Date: September 21, 2022

Re: 22-23-03MO – JUSD Storage Facility – Addendum No. 3

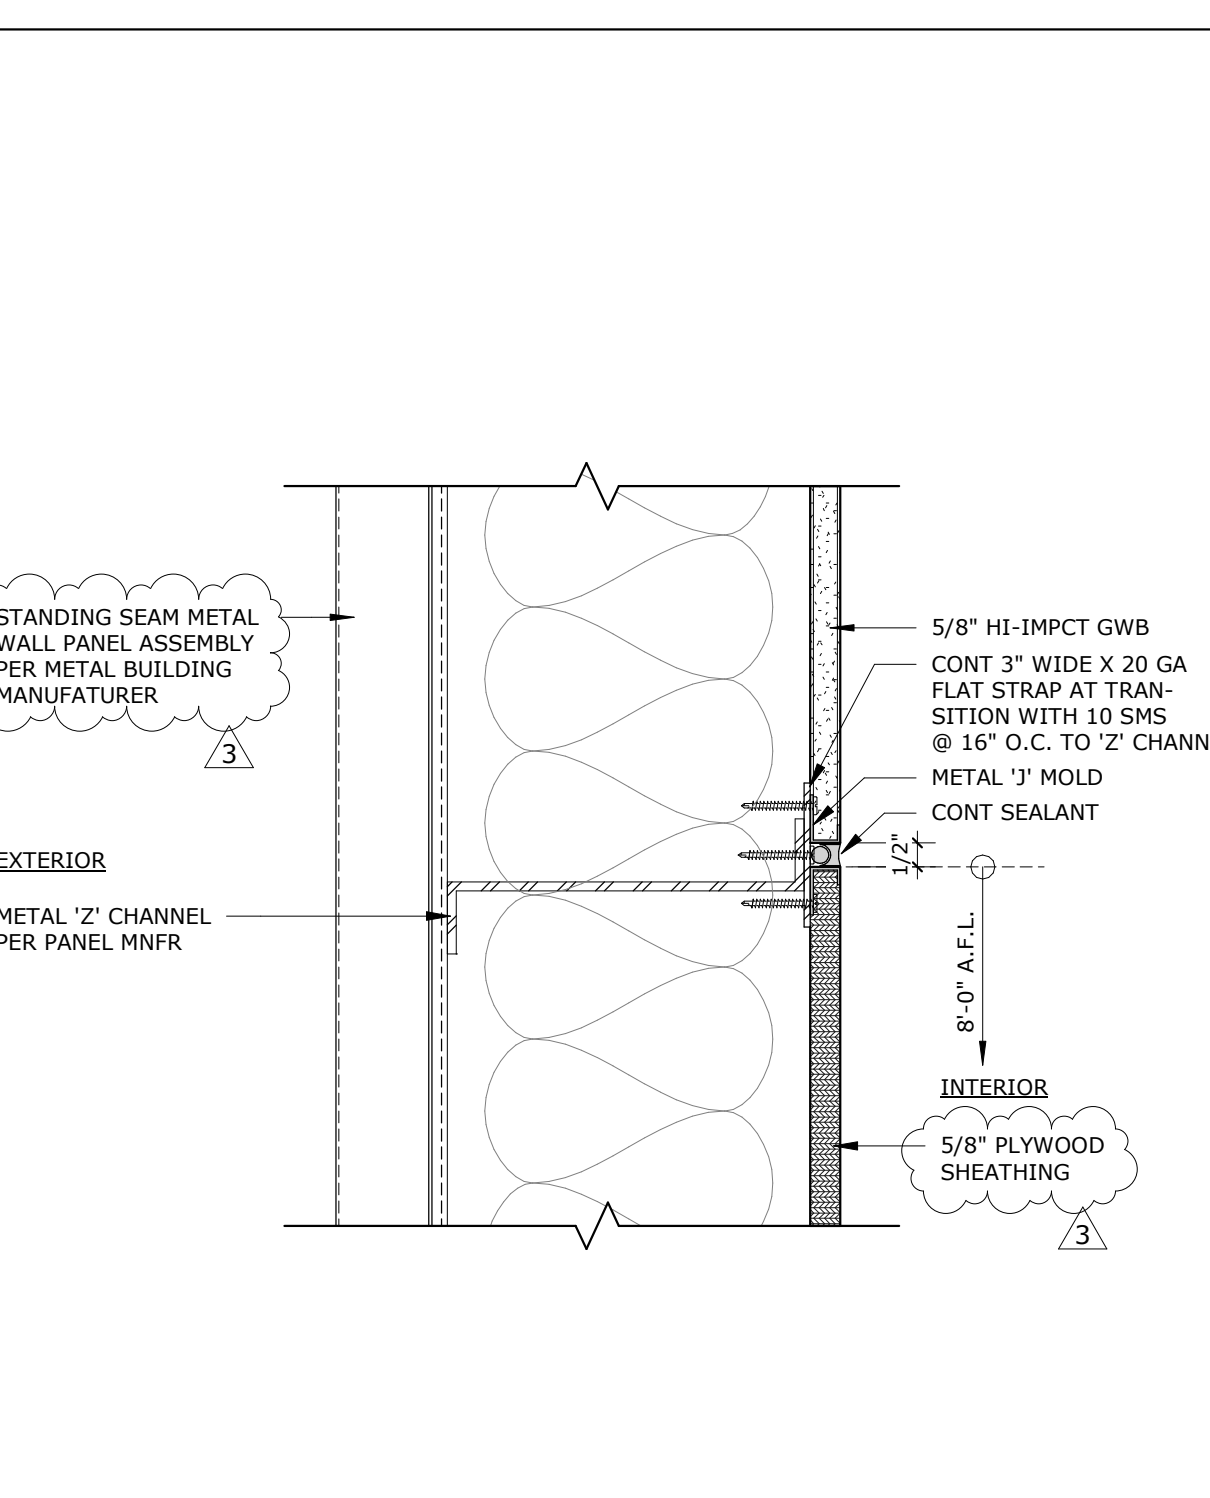
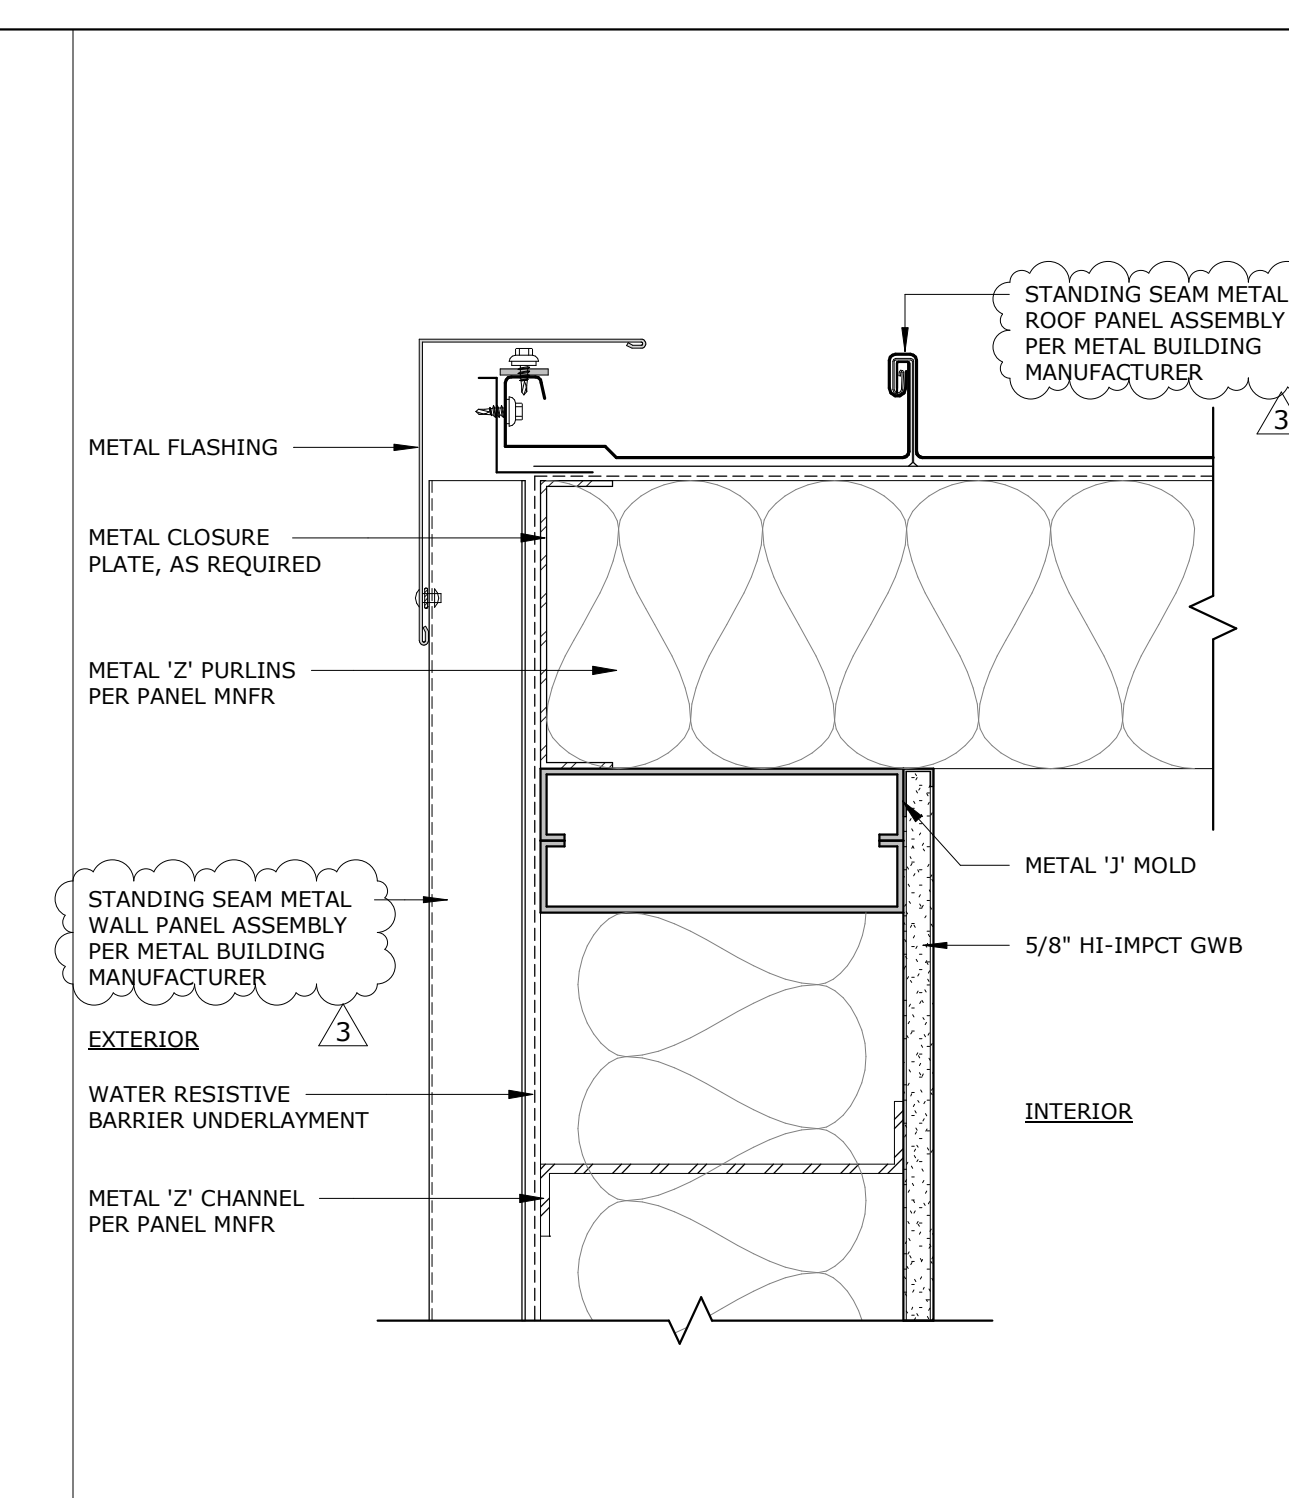
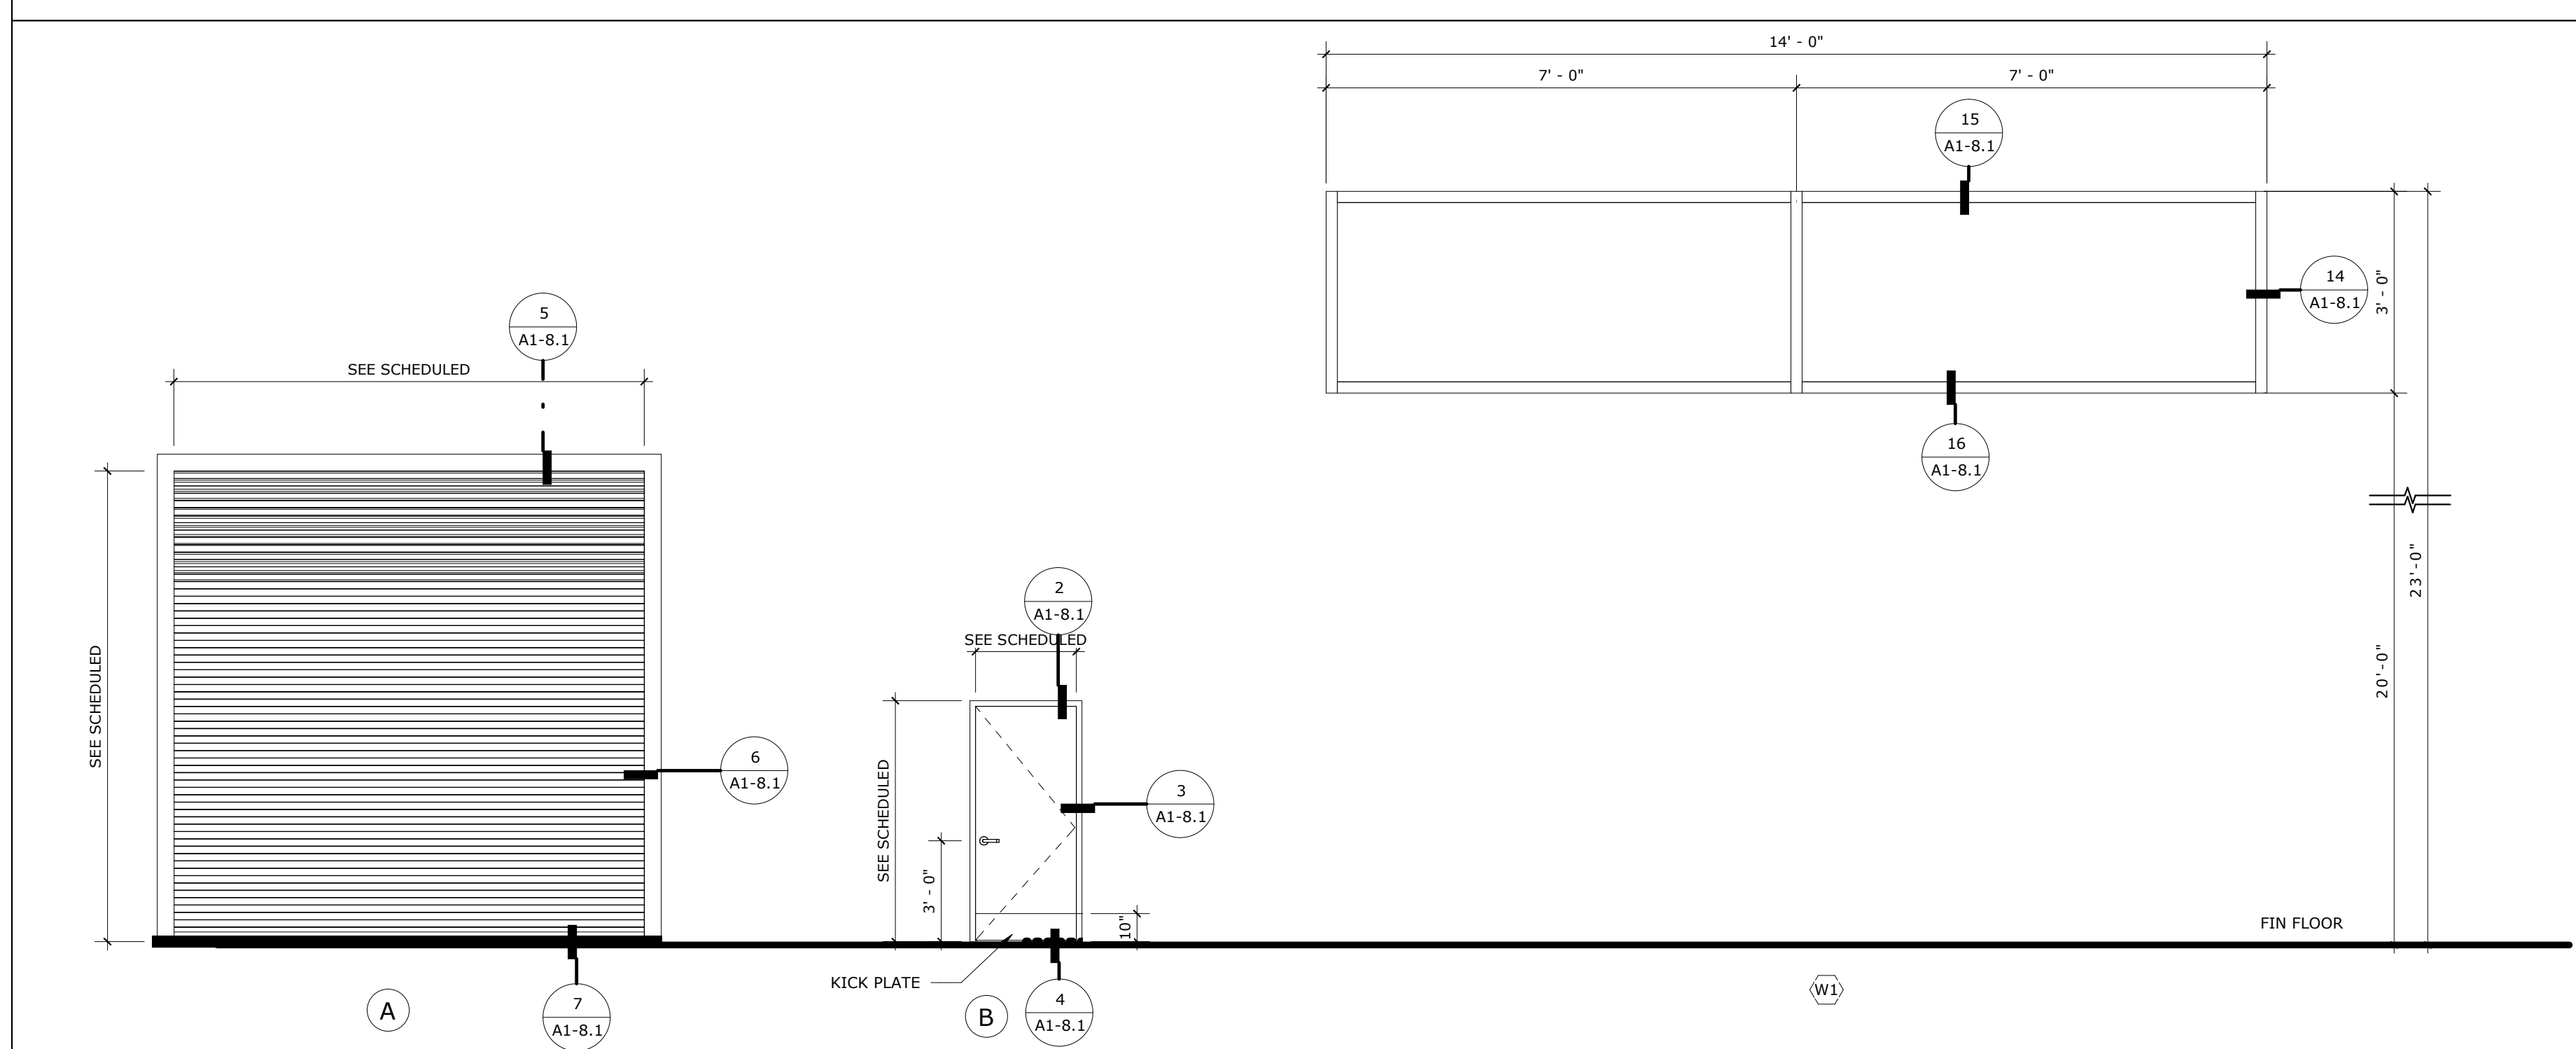
Item # 5 Q: Some exterior wall details indicate Densglass between the metal framing and the metal wall siding, but some details don’t. What is the intent?

- Item #7 Q: Re: A1-7.1/ A1-8.1 17/18
Please confirm HT CP 5/8” 6WP is plywood & Gypsum to be finished and painted.
A: High Impact GWB need no paint.
B. Height as indicated on bldg. section A1-7.1, See attached sheet

A: No Densglass, this is a pre-fabricated metal building, see attached revised sheet A1-8.1

C. On detail 18/A1-8.1 height of plywood is indicated, See attached sheet
- Item #8 Q: Re: Add #2 Fire Suppression HVAC
Will both F.S/ HVAC be a Bid, or will AIA provide drawings?
A: Will be bid

FOUNDATION PLAN **S1-1.1**

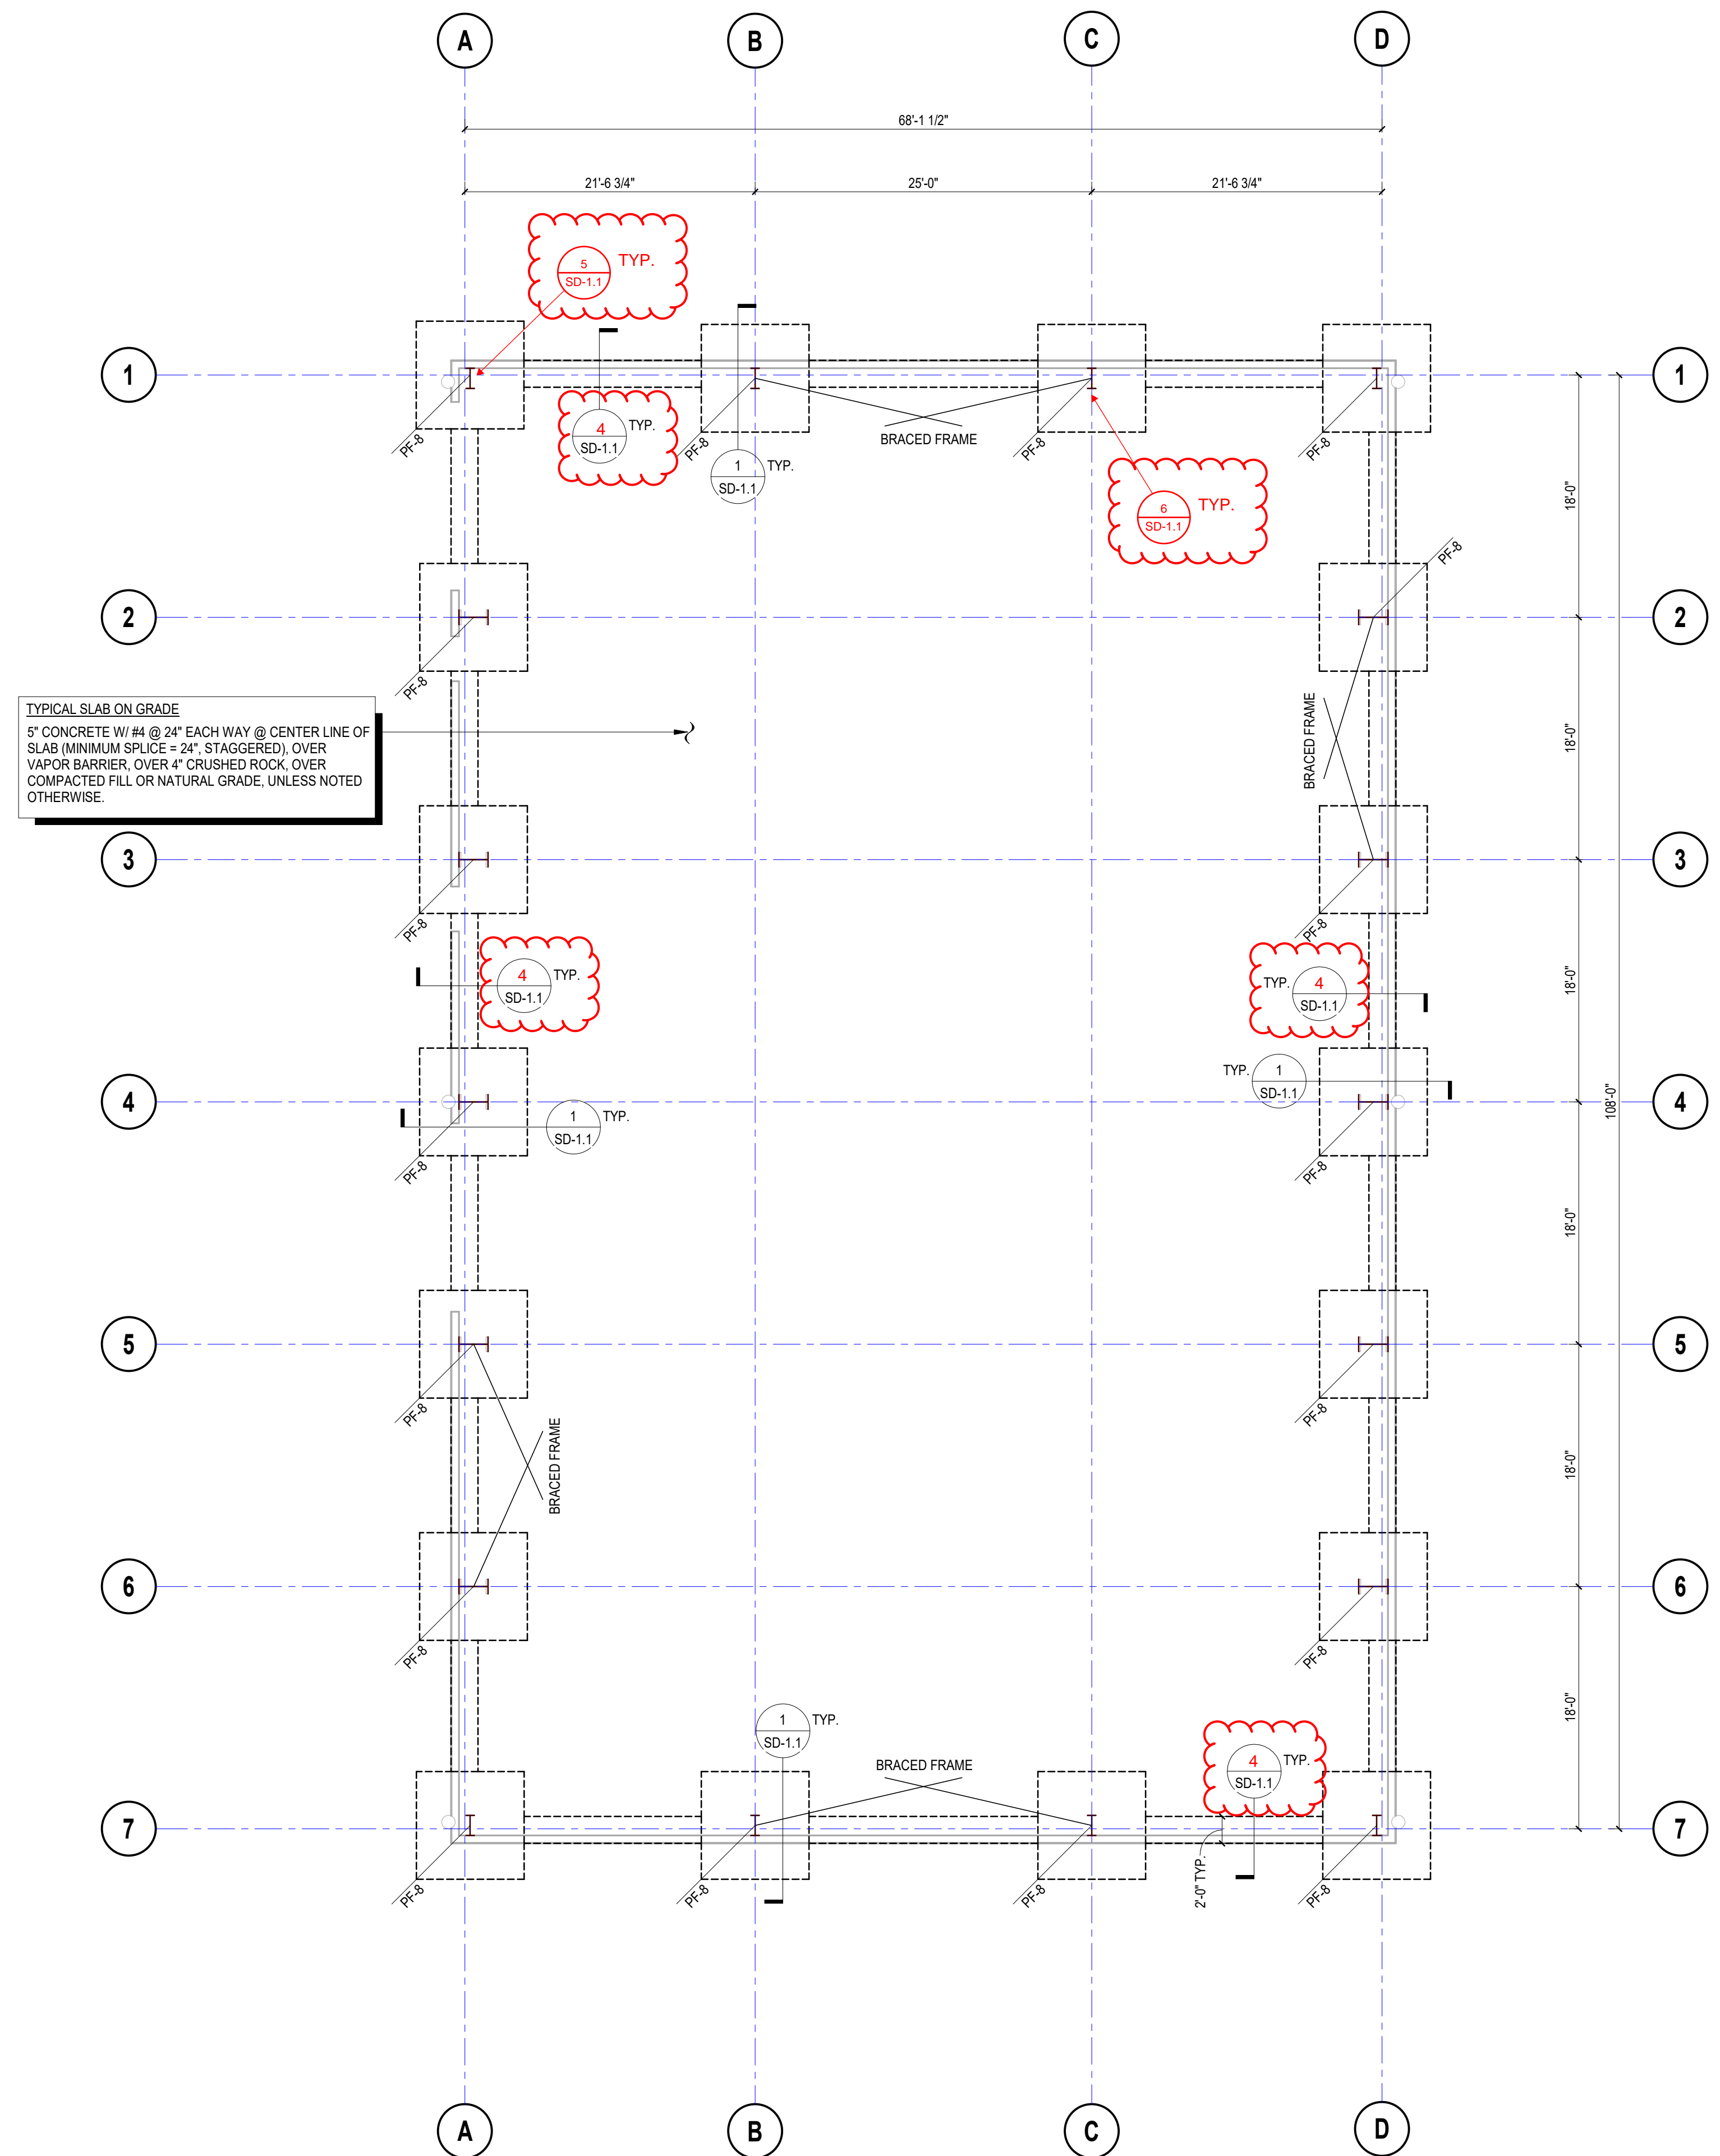
ITEM #2 Q: The Foundation Plan S1-1.1 indicates a grade beam callout of 8/SD1.11. This detail does not exist. Please provide.

ITEM #3 Q: Detail 1 on SD1.1 notes “See Plan” for size of footings. However, the Foundation plan S1-1.1 does not show any dimensions. Please provide dimensions.

A; See attached revised S1-1.1

A: See attached revised S1-1.1
